**SUSQUEHANNA STEAM ELECTRIC STATION  
PROPOSED AMENDMENT NO. 237 TO LICENSE  
NPF-14 AND PROPOSED AMENDMENT NO. 203  
TO LICENSE NPF-22: RESIDUAL HEAT REMOVAL  
AND ULTIMATE HEAT SINK  
PLA-5319**

**Docket Nos. 50-387  
and 50-388**

**Attachment 1 to PLA-5319**

**Safety Impact Assessment**

Figure 1

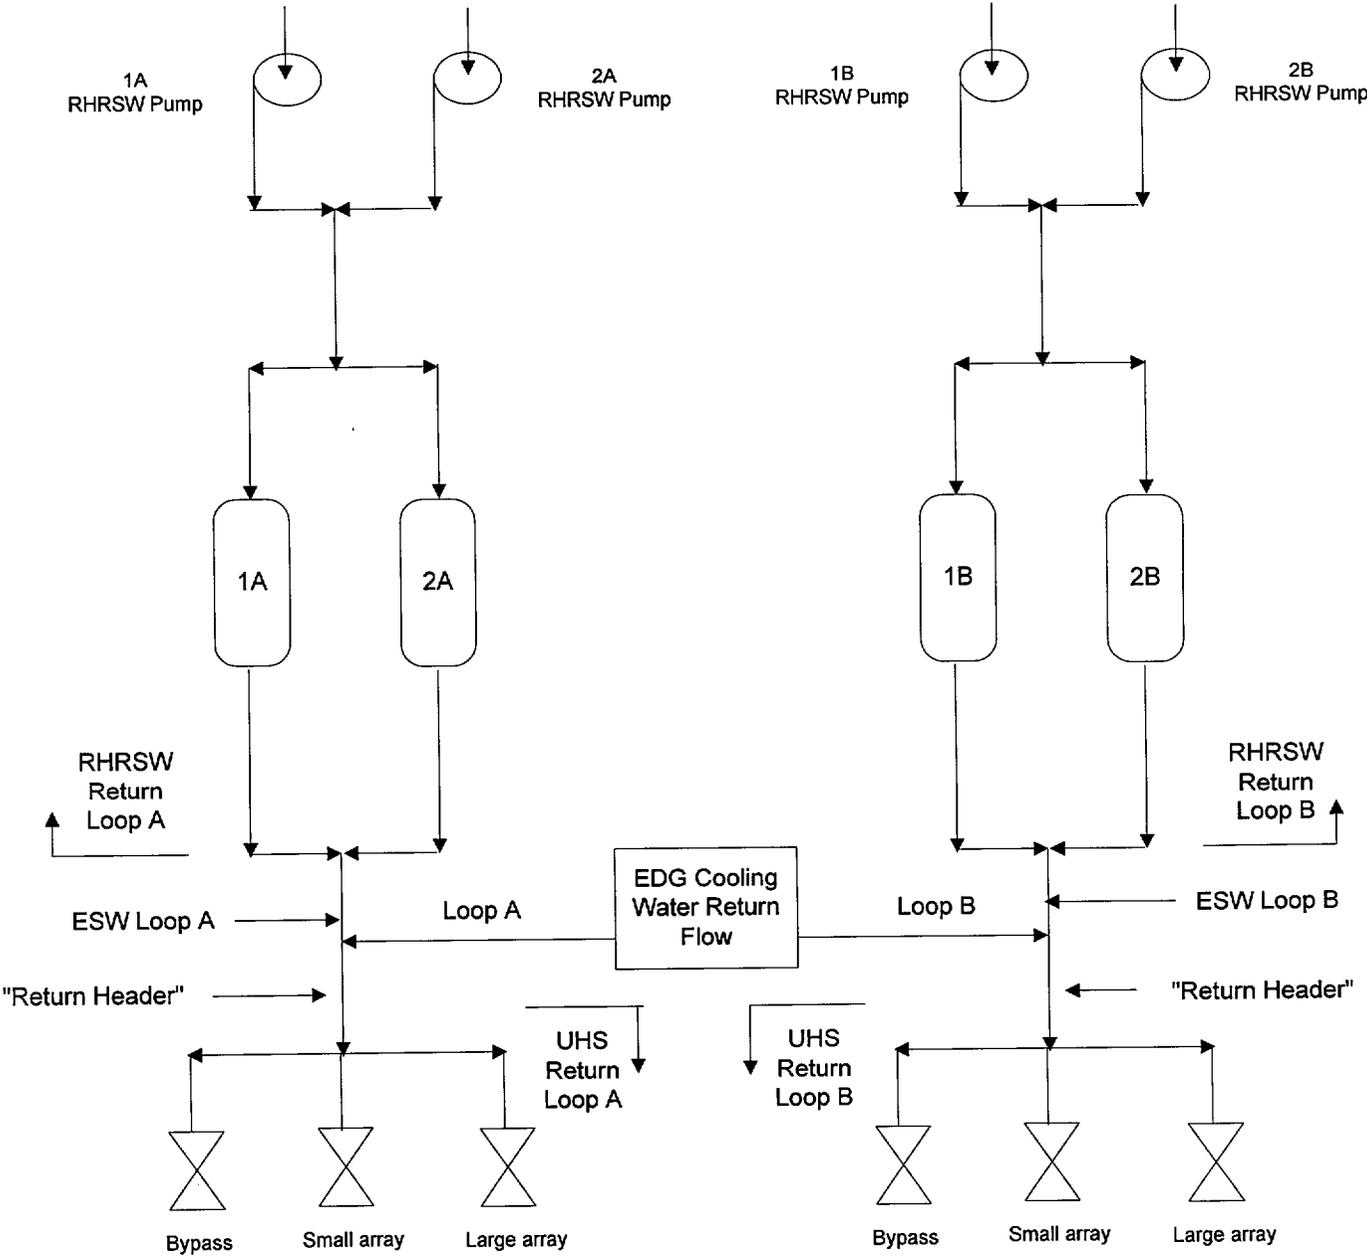
The RHRSW/UHS system is presented schematically in Figure 1. The RHRSW system is composed of two loops, with two subsystems assigned to each loop. Each subsystem contains a suction source, one pump, a return header, a heat exchanger, valves, piping and associated instrumentation. The RHRSW pump, taking suction from the ultimate heat sink (UHS), pumps cooling water through the tube side of the RHR heat exchanger. After removing heat from the RHR heat exchanger, the water is discharged back to the UHS through the return header. The discharge headers are shared with the emergency service water (ESW) system and direct the return flow from both the RHRSW and ESW systems to a network of UHS return loops. The return loops are manually controlled and can route the return flow through the spray arrays, where the heat is dissipated directly to the atmosphere, or the spray bypass line, where the return flow, consequently the

discharged heat, goes directly to the UHS. A single large spray array or the combination of both small spray arrays is sufficient to remove the shutdown heat load from a design basis event. The individual RHRSW loops may be aligned to either unit, as required. The minimum requirement for the safe shutdown of both units, under either normal or accident conditions is that two of these RHRSW subsystems must be operable.

The UHS return loops must be manually aligned to use either set of spray nozzles. Manual alignment to either array requires manual closure of the spray array bypass valves, which are automatically opened on RHRSW and/or ESW pump start. The spray bypass valves are normally open and receive an automatic open signal on RHRSW/ESW pump start to prevent the possibility of running the pumps under dead head conditions. Use of the spray arrays also requires the manual opening of either the large or the small spray array valves, or both valves, if available. Analysis of the design basis accident for the UHS shows that one large spray array is required to dissipate the heat generated during a design basis loss of coolant accident (LOCA), with concurrent safe shutdown of the non-LOCA unit.

The failure of a spray bypass valve in one UHS return loop to close on demand results in the inability to use the spray arrays on that UHS return loop and, as a result, this failure is the worst case single failure for the combined RHRSW/UHS system. The UHS design analysis has concluded that, with a spray bypass valve open, opening either of the spray array valves on the affected subsystem would not produce sufficient spray nozzle pressure to effectively transfer the heat load to the environment. Operations Staff would not manually load RHRSW pumps on a UHS return loop that has a failed spray array bypass valve, according to plant procedure. Thus, the failure of a spray array bypass valve to close effectively causes two of the four RHRSW subsystems (the subsystems on the loop that contains the failed valve) to be unavailable. The UHS analysis does account for the alignment of ESW system heat loads on the UHS return loop with the failed bypass valve, therefore, the affected ESW subsystems need not be considered inoperable.

Failure of one of the large spray array valves to open on demand leaves the plant with a single large spray array and two small spray arrays available. This configuration is not single failure proof, because a failure of the spray bypass valve in the opposite loop results in only a single small spray array available for heat dissipation, which is insufficient to dissipate the heat transferred in the design basis event.
